Re: CUP 22-00 (Arnold)
Concrete Plant CUP

Response to Comments dated January 23, 2024

Conditional Use Permit Justification Report

CUP 22-00 (Arnold)
13370 SW 170th Street
Archer Florida
Parcel Number: 05046-000-000

C-000
 COVER &
 SHEET INDEX

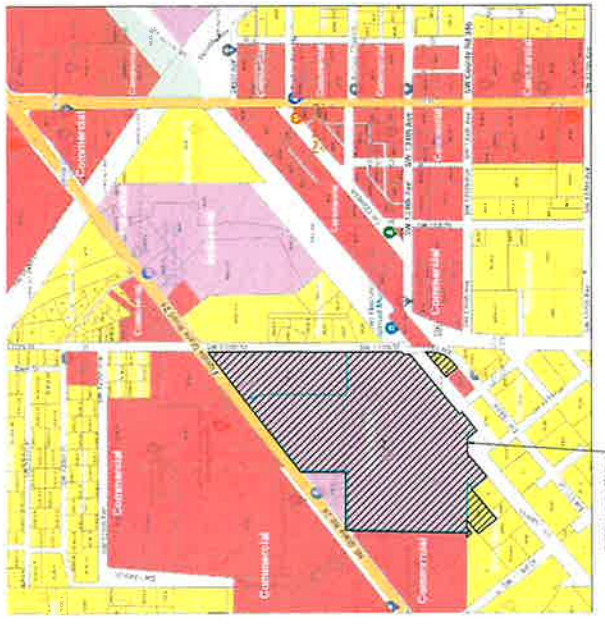
The Project Information section on Sheet No. C-000 lists five parcel identification numbers. Of the five parcel identification numbers only two are classified and zoned industrial, 05046-000-000 and 05047-000-000. The others three parcel identification numbers, 05050-000-000, 04993-000-000, and 04992-000-000 are classified and zoned

residential The applicant needs to remove from Sheet C-000 parcel identification numbers 05050-000-000, 04993-000-000, and 04992-000-000.

Agreed, 05046-000-000 and 05047-000-000 are the industrial zoned parcels. Please see the attached revised application and plans and legal description and CUP Justification Report.

MASTER SITE
 PLAN & KEY MAP
 C-100

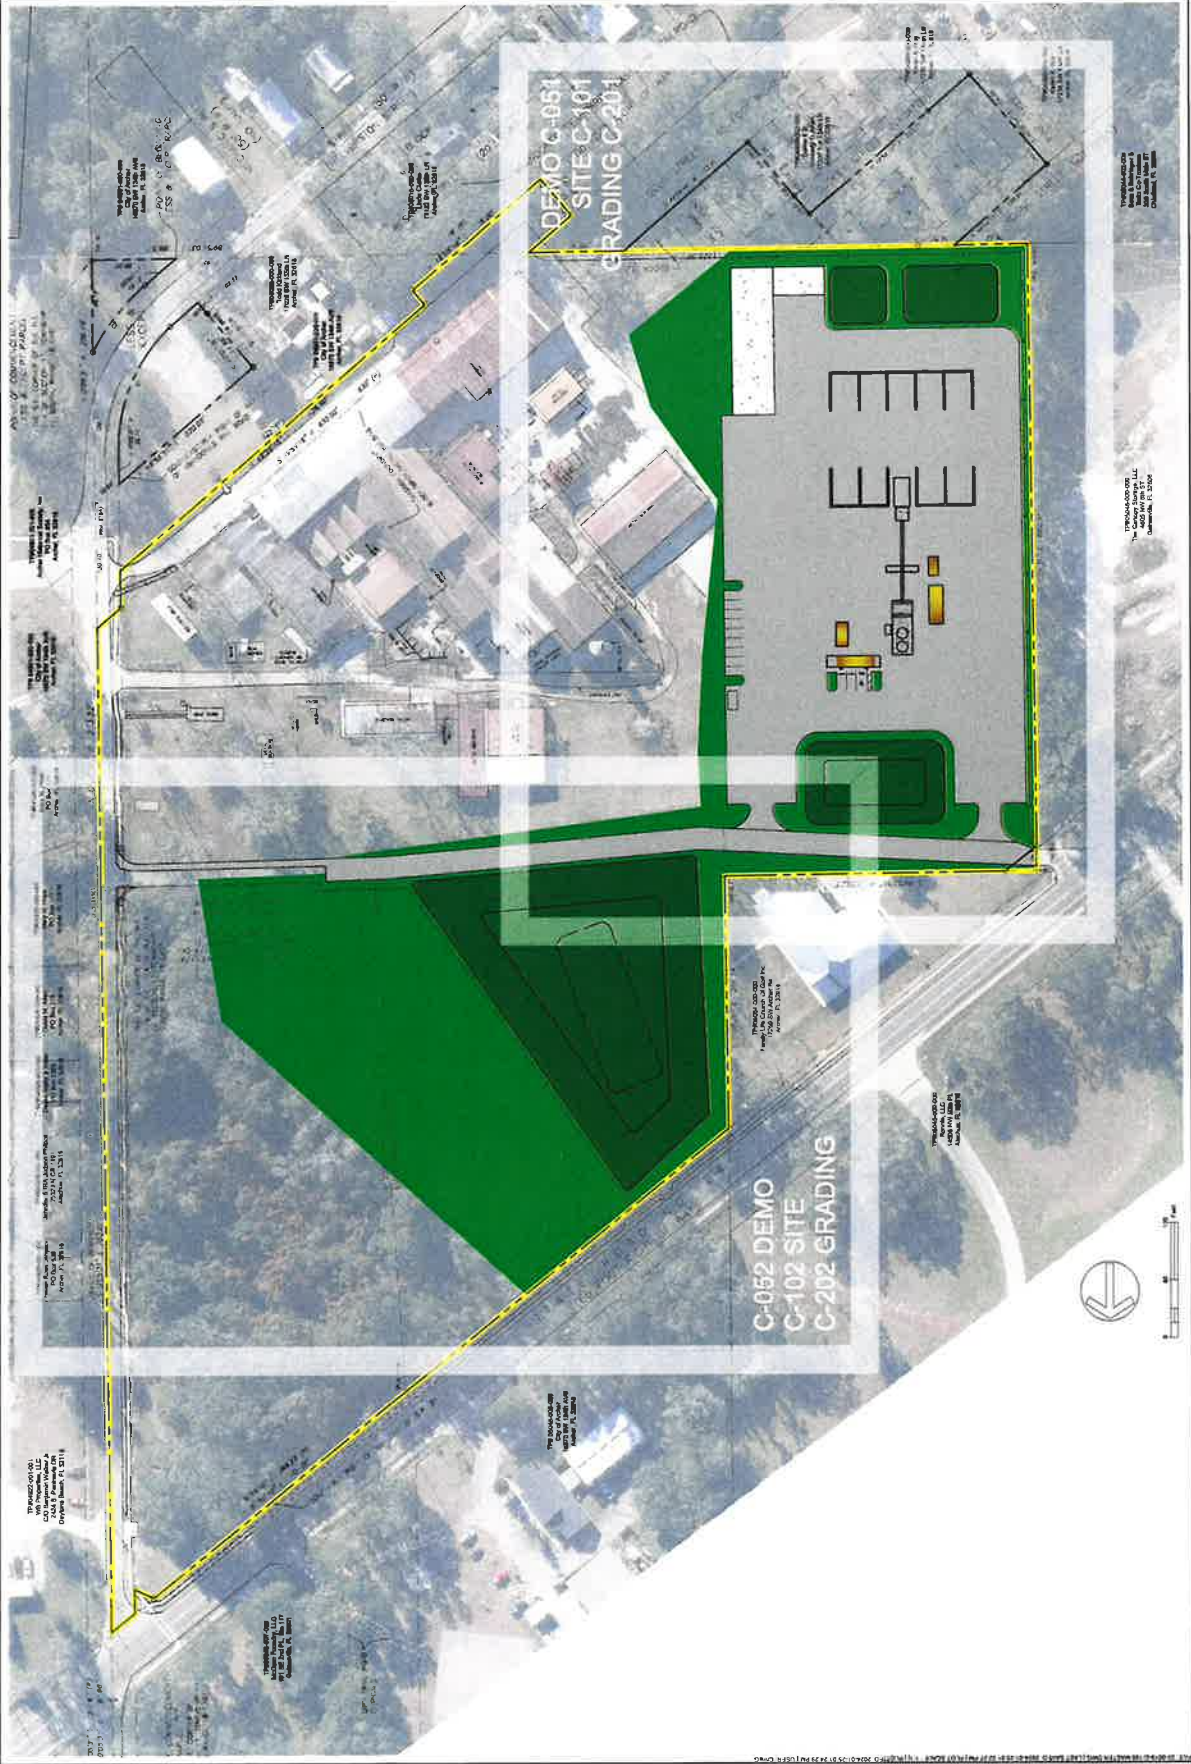
The site plan shows a proposed 12 foot x 40 foot office building. However, the height and type of the proposed building is not stated. The applicant needs to update the site plan to show the area, height and type of the proposed building.

A note has been added to C-100 with the construction type and height and plans added to the plan set.

See the revised H/C Parking Detail and dimensions have been added to the site sheet C-100.

C-101

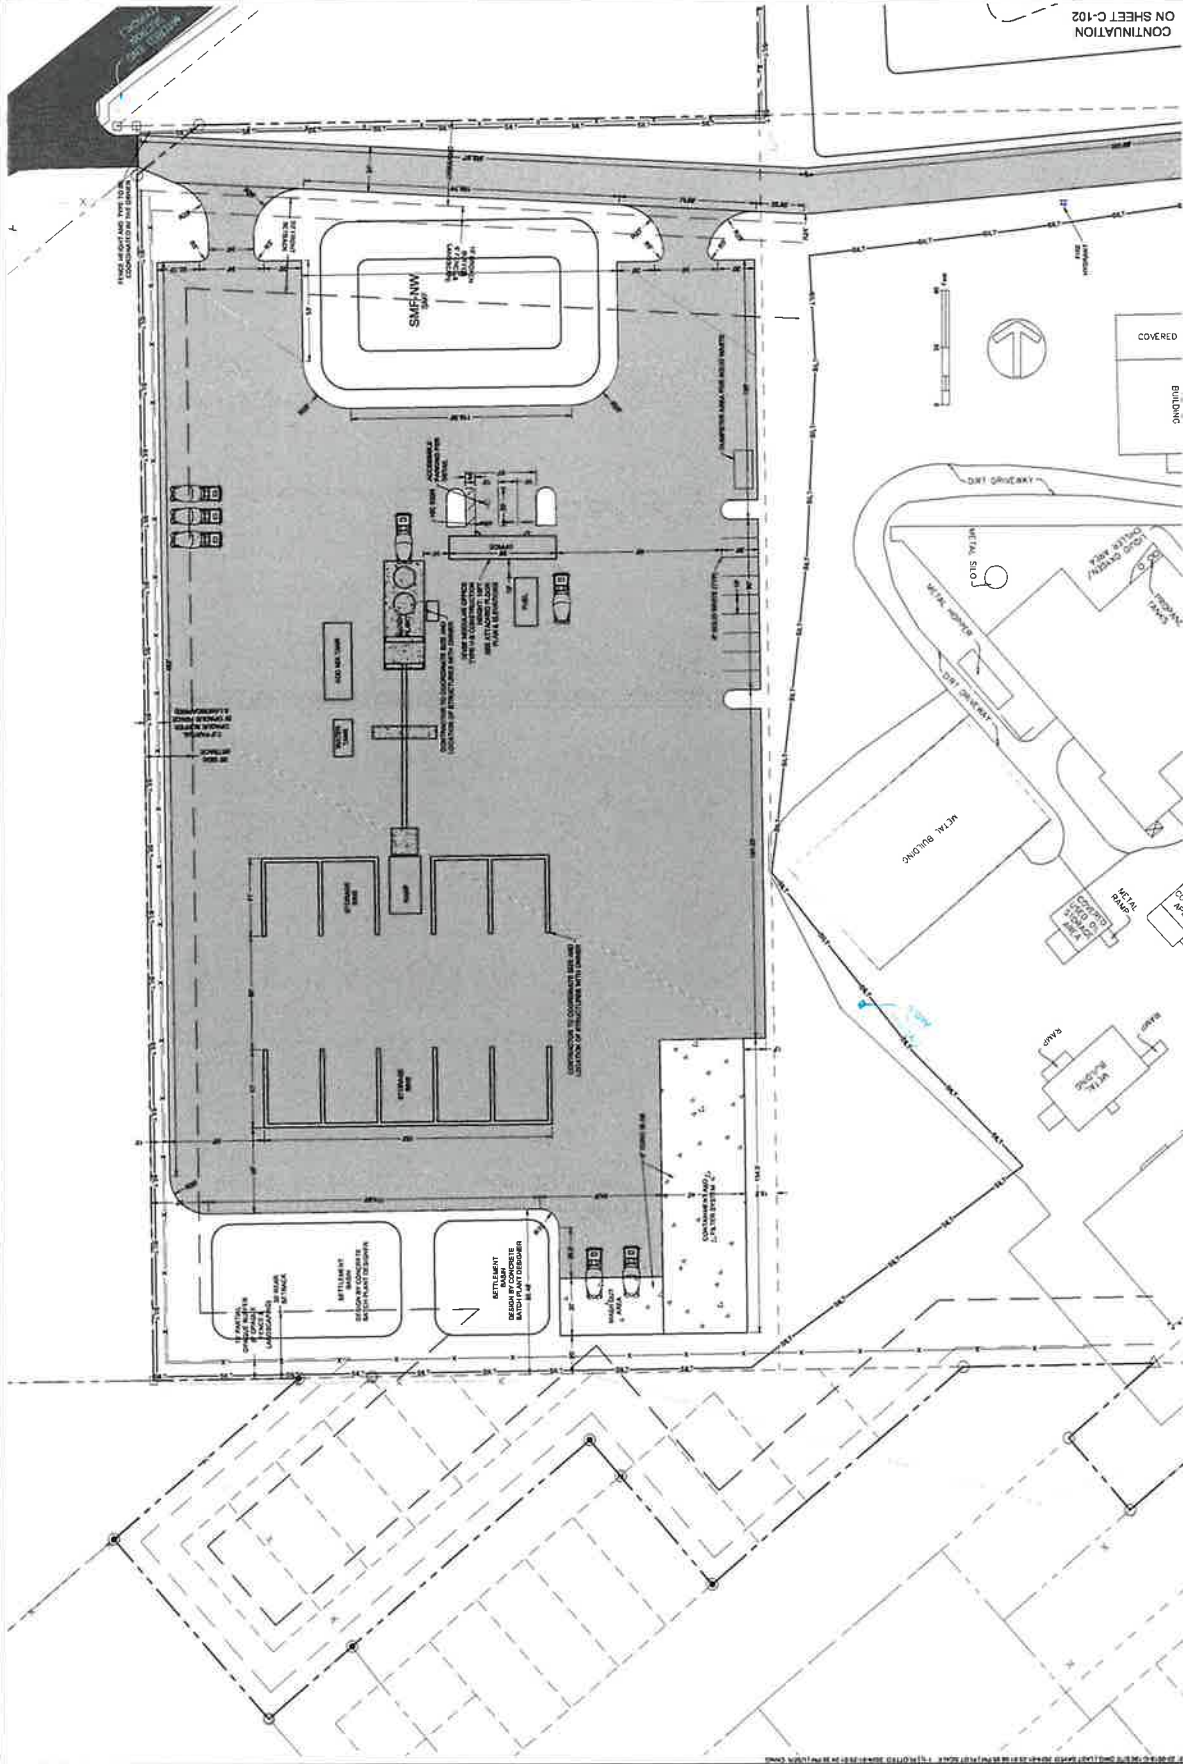
The applicant's cover letter states that an existing fire hydrant is located in the center of the site. However, the location of said existing fire hydrant is not clearly labeled on the site plan. The applicant needs to update the site plan to clearly show and label the existing fire hydrant

The Fire Hydrant is now shown at the bottom right corner of sheet C-101 and called out for your reference.

C-102

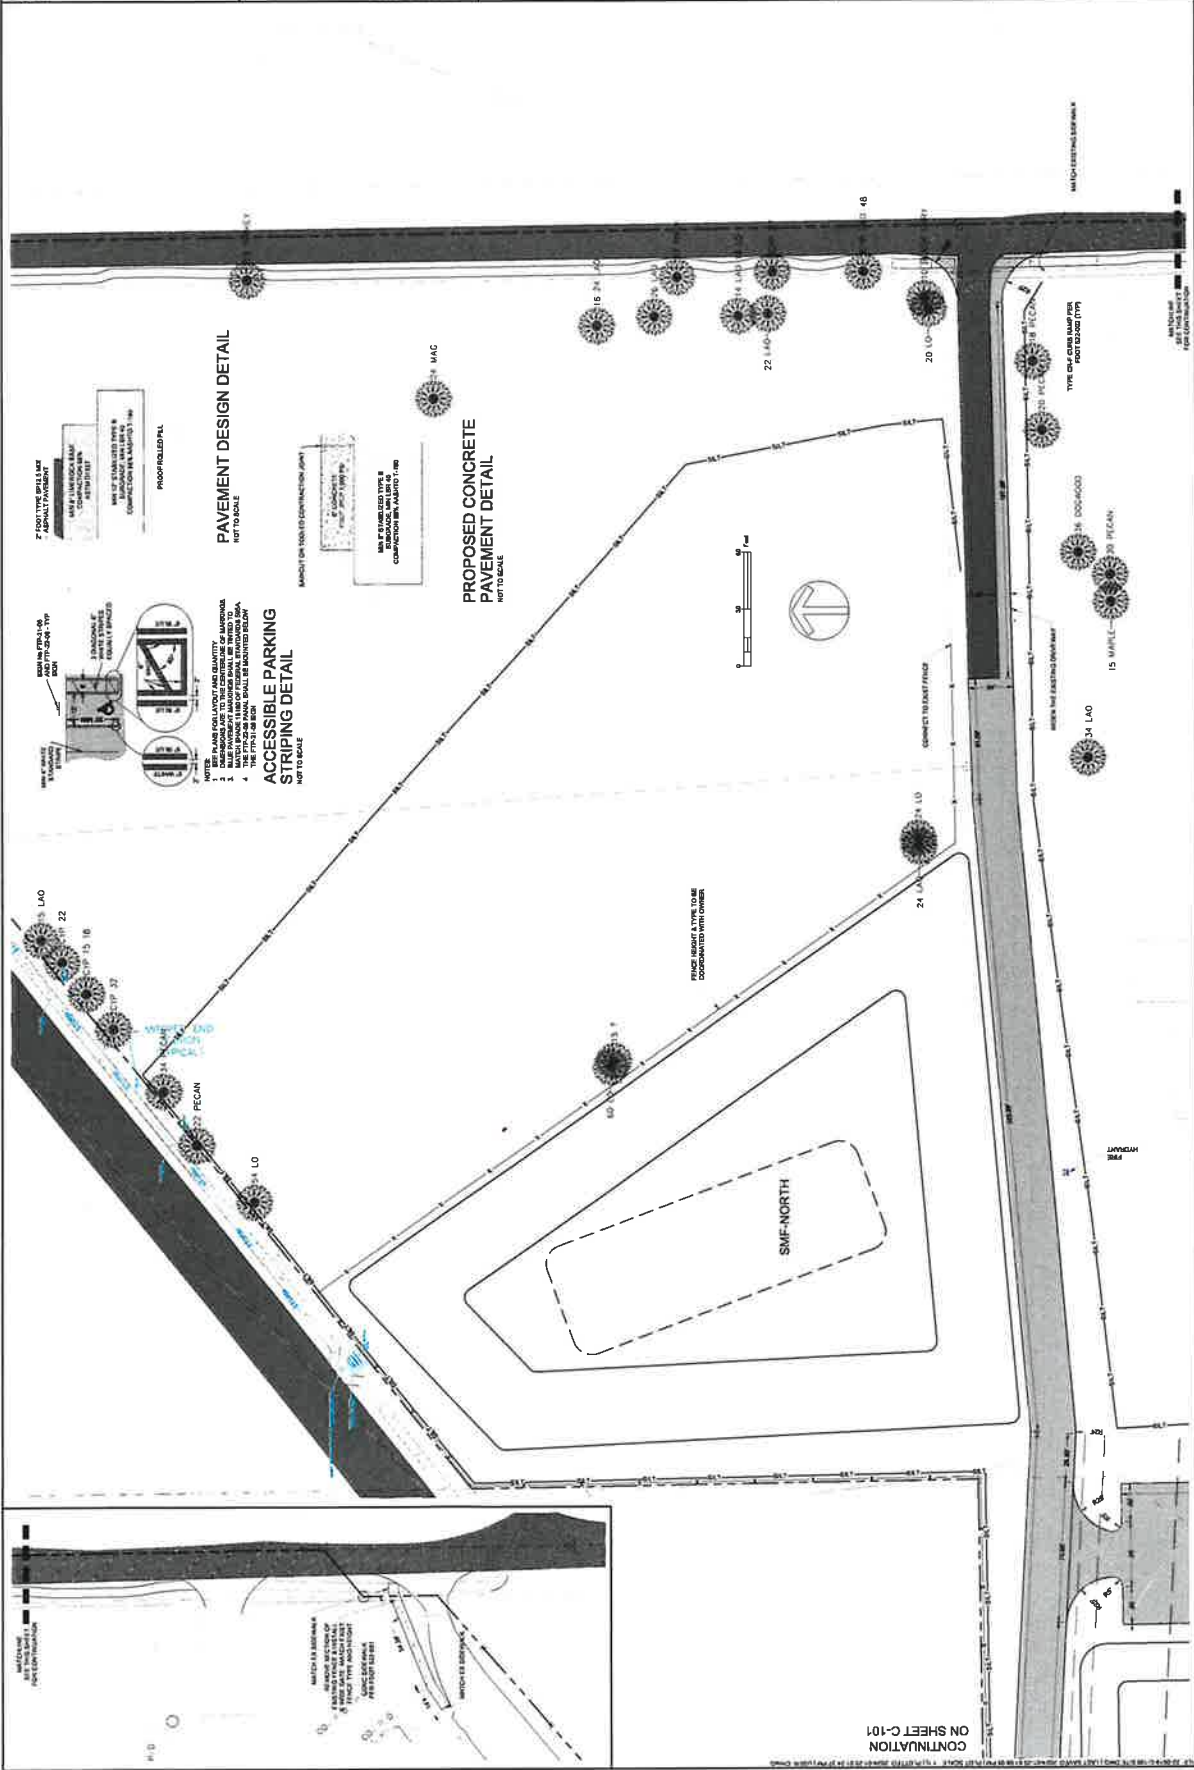
The accessible parking detail shown on Sheet No. C-102 shows the proposed handicapped parking space is 12feet by 18feet. However, according to Section 21.06.5 of the Land Development Code the minimum off-street handicapped parking space is to be a minimum of 12 feet in width by 20 feet in length. Therefore, the site plan needs to be updated to show the handicapped parking space as 12 feet in width by 20 feet in length on both Sheet C-101 and Sheet C-102.
